# HISTORIC AND DESIGN REVIEW COMMISSION

June 17, 2020

**HDRC CASE NO:** 2020-239  
**ADDRESS:** 210 LAVACA ST  
**LEGAL DESCRIPTION:** NCB 713 BLK 10 LOT 11  
**ZONING:** RM-4, H  
**CITY COUNCIL DIST.:** 1  
**DISTRICT:** Lavaca Historic District  
**APPLICANT:** V Yuan/Lake/Flato Architects  
**OWNER:** HILL STACEY L  
**TYPE OF WORK:** Front yard landscape and hardscape, rear patio enclosure  
**APPLICATION RECEIVED:** May 19, 2020  
**60-DAY REVIEW:** Not applicable due to City Council Emergency Orders  
**CASE MANAGER:** Huy Pham  
**REQUEST:**

SOUTHERN LANDSCAPES & CONSTRUCTION	PROJECT:	LANDSCAPE REDEVELOPMENT • STACEY HILL HOUSE		
	LOCATION:	210 LAVACA, SAN ANTONIO, TEXAS		
	DESIGNER:	HECTOR J. VILLARREAL		
	SCALE:	1/4" = 1'-0"	PLANTING LAYOUT	
	DATE:	4-14-20	SHEET L-2

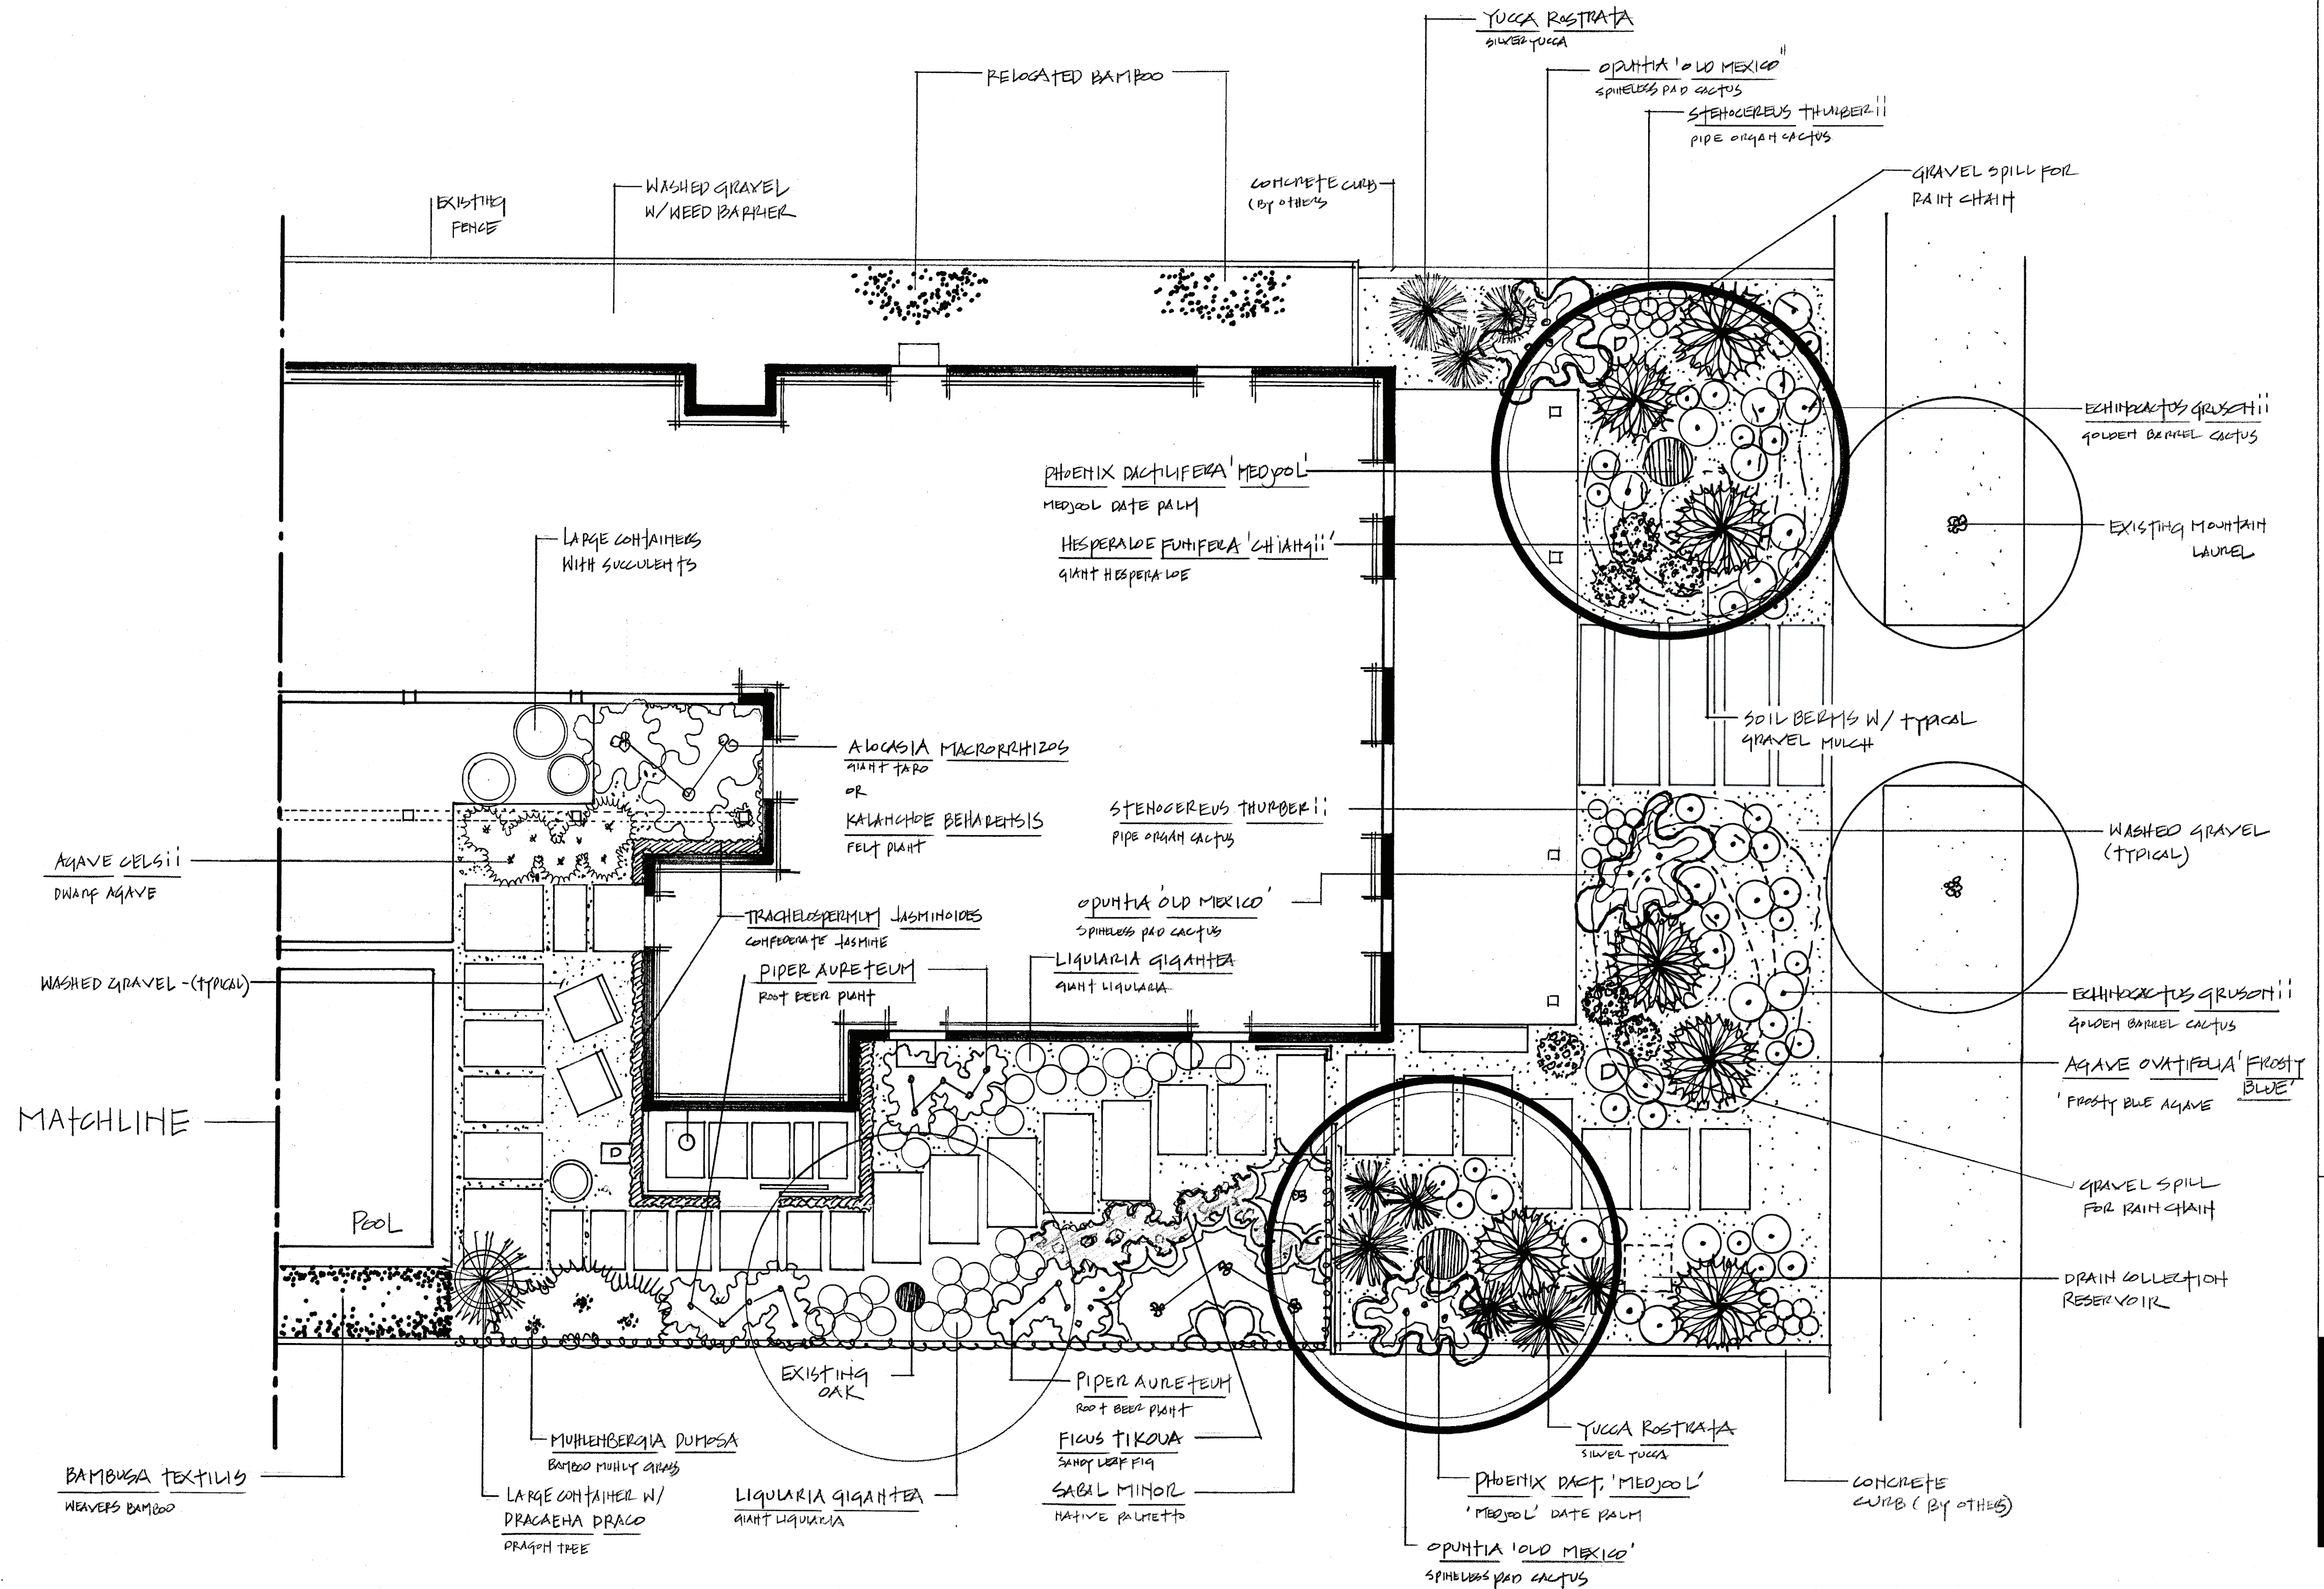
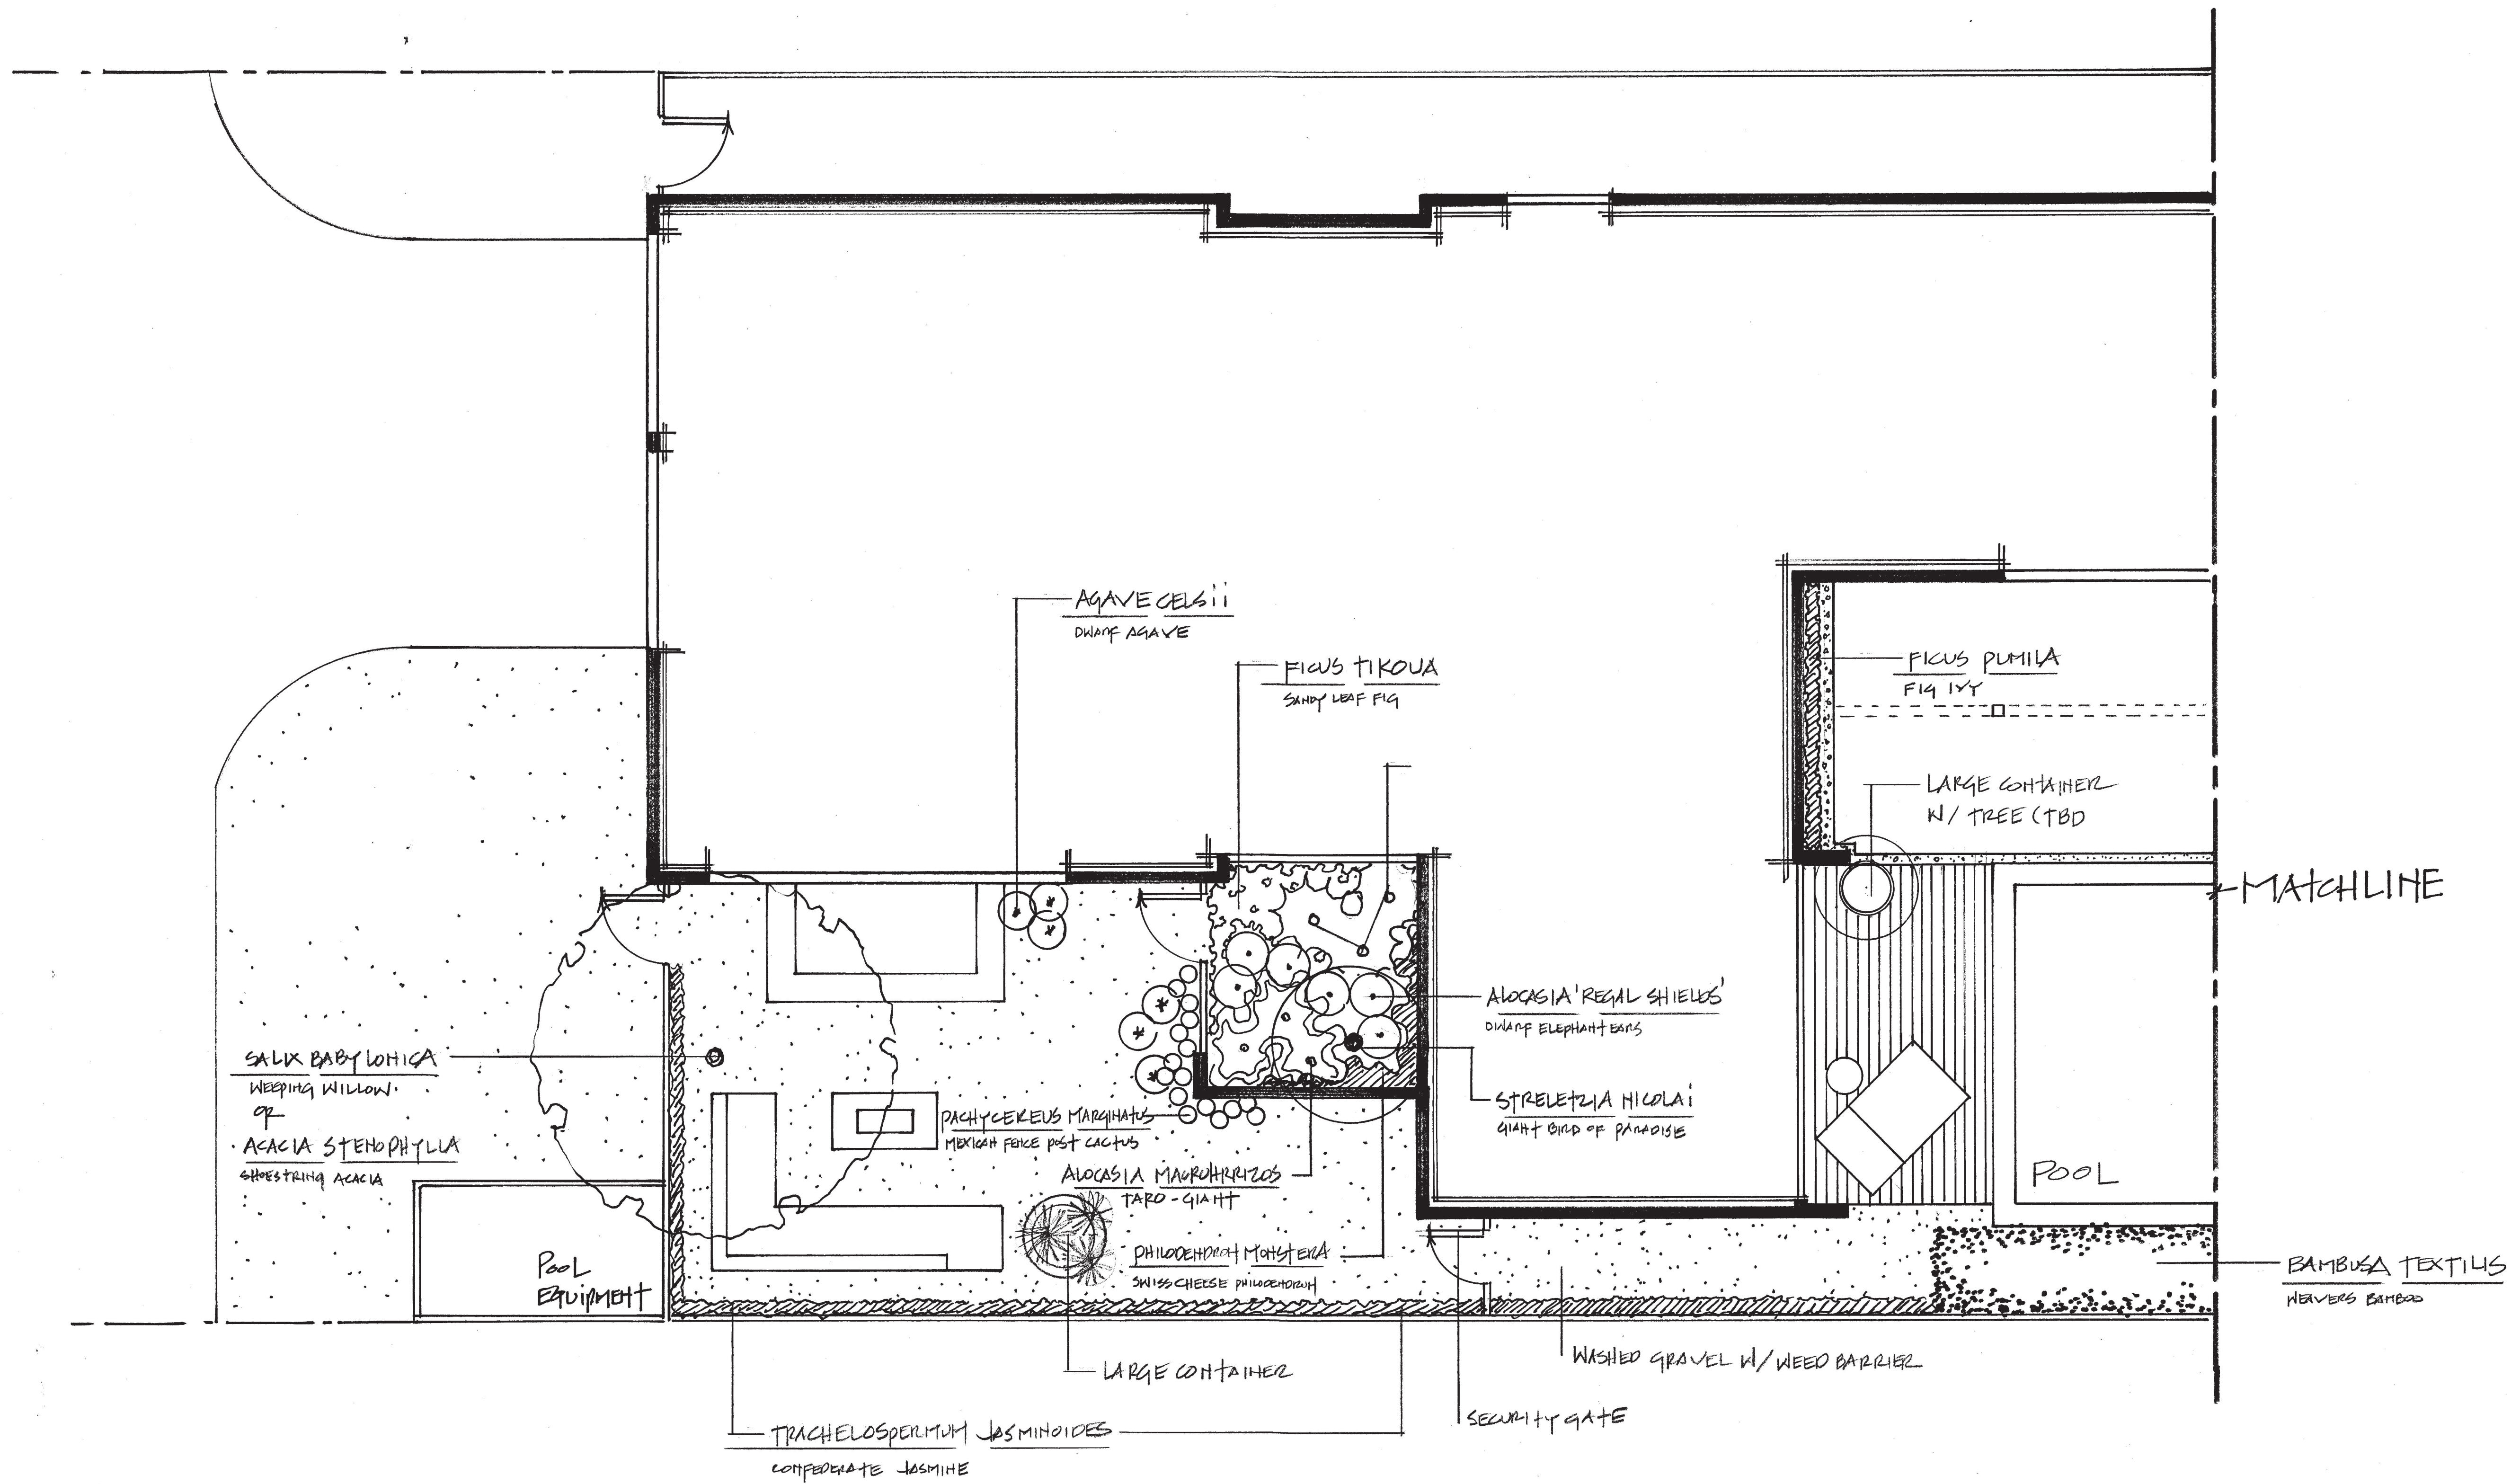
- c. LANDSCAPING – The applicant has proposed to remove the natural lawn to feature two primary berms flanking the centered walkway, including xeriscape plantings including: cacti, yucca, laurel, agave, and palm with washed gravel beds, a drain collection reservoir, and a gravel spill throughout. Per the Guidelines for Site Elements 1.A.ii., applicants should minimize changes in topography resulting from new elements, like driveways and walkways, through appropriate siting and design; new site elements should work with, rather than change, character-defining topography when possible. Staff finds the installation of berms appropriate if drainage is directed away from the front porch. Per the Guidelines for Site Elements 7.A. historic lawn areas should never be reduced by more than 50%. Staff finds that the proposed landscaping features an appropriate amount of xeriscaping plantings compared to areas of hardscape.

- i. That the limestone pavers feature a natural color and texture and may not be substituted with segmented poured concrete paver limited to consideration for new construction and rear yards.
- ii. That the installation of the berms feature drainage that directs water away from the front porch.
- iii. That the front yard maintains at least fifty (50) percent vegetative ground cover.

Lavaca Street Proposed Elevation with Landscape Berms

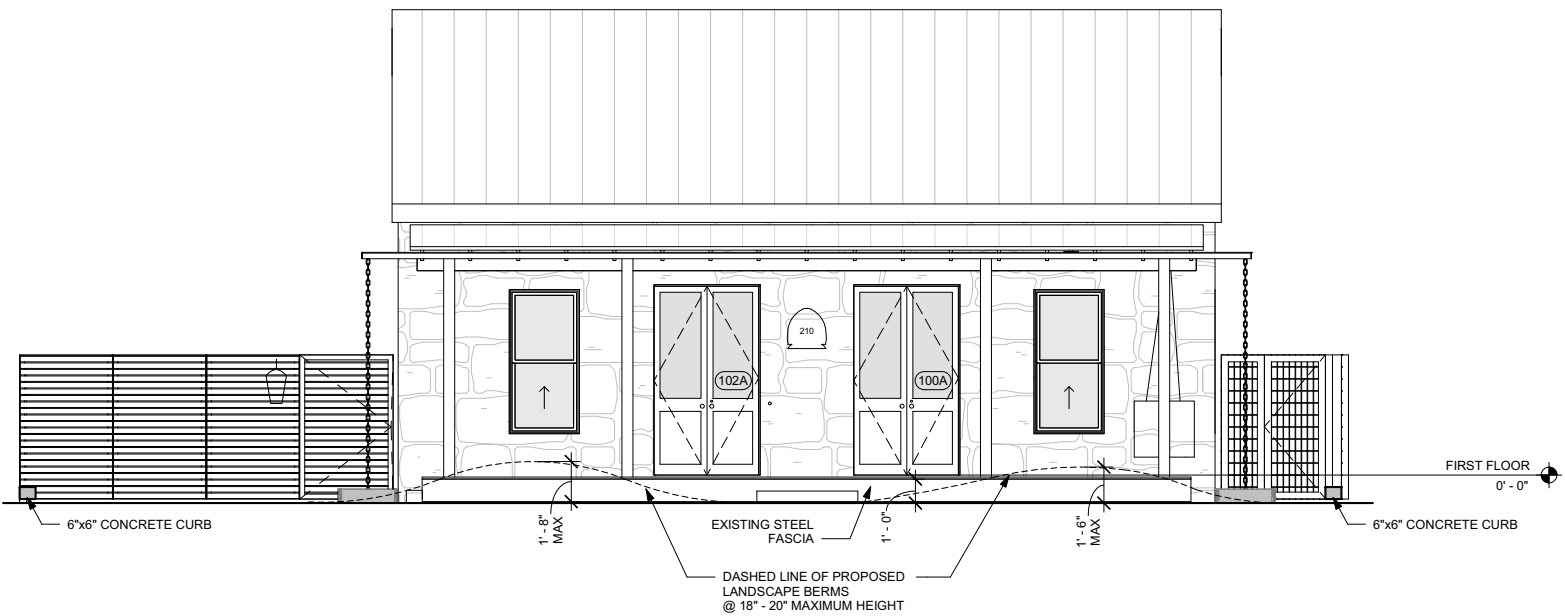
- b. WALKWAY – The applicant has proposed to remove the poured concrete walkway to install limestone segmented pavers. Per the Guidelines for Site Elements 5.A.iii., applicant should follow the historic alignment, configuration, and width of sidewalks and walkways. Staff finds that the existing poured concrete walkway is not original the structure, does not relate to the period of significance for the structure, and is therefore eligible for an appropriate replacement. Staff finds that the proposed limestone pavers relate to vernacular step paths found in Lavaca if the pavers feature a natural color and texture. The proposed requested may not be substituted with segmented poured concrete paver limited to consideration for new construction and rear yards.

South Elevation - Pool Bath Building with proposed fence enclosure

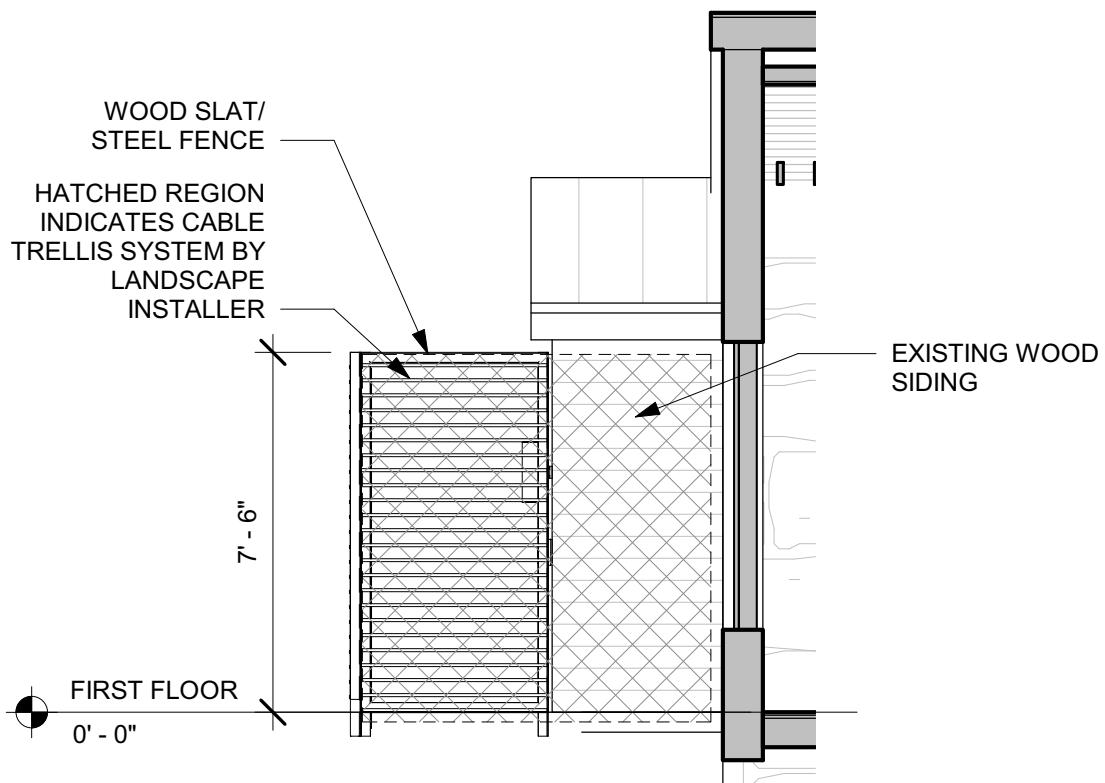
- d. PATIO ENCLOSURE – The applicant has proposed to install wood and steel screens to enclose a rear patio

addition. Per the Guidelines for Additions 4.A.iii., applicants should consider integrating contemporary interpretations of traditional designs and details for additions. Staff finds the proposed screening is minimally visible from the front right-of-way and relates the simplified wood forms of the historic structure and existing addition.

Refugio Alley Elevation with Aluminum and Glass Garage Doors

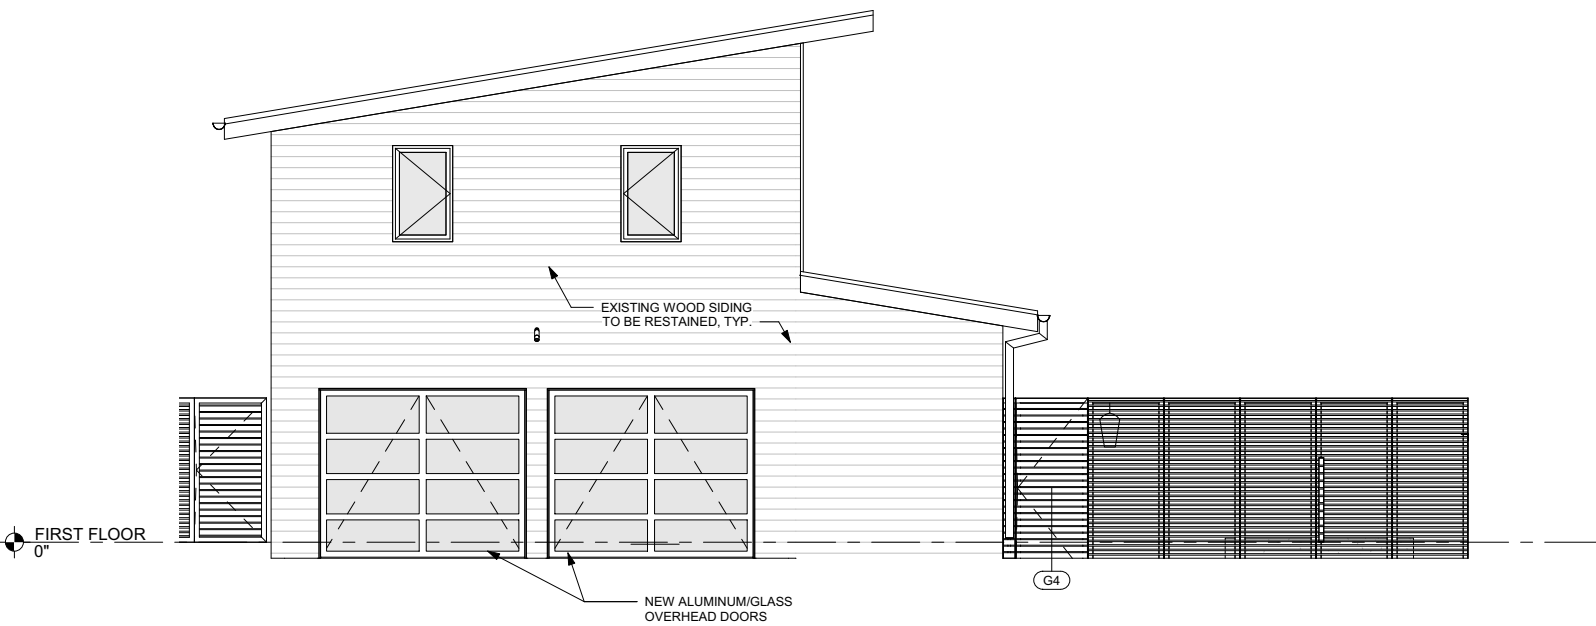
- e. GARAGE DOORS – The applicant has proposed to replace the horizontal wood plank garage doors on the non-historic, detached garage with new metal framed garage doors with opaque glass panels. Per the Guidelines for New Construction 5.A.v., applicants should incorporate garage doors with similar proportions and materials as those traditionally found in the district. Staff finds that the proportions remain appropriate, but the metal and glass configuration do not relate to garage doors traditionally found in the district and such modification is also highly visible on Refugio. Staff finds that a wood garage door with a band of windows across the top would be more appropriate than the proposed doors.

Staff does not recommend item 4, garage door replacement, based on finding e. Staff finds that that a wood garage door with a band of windows across the top should be installed.
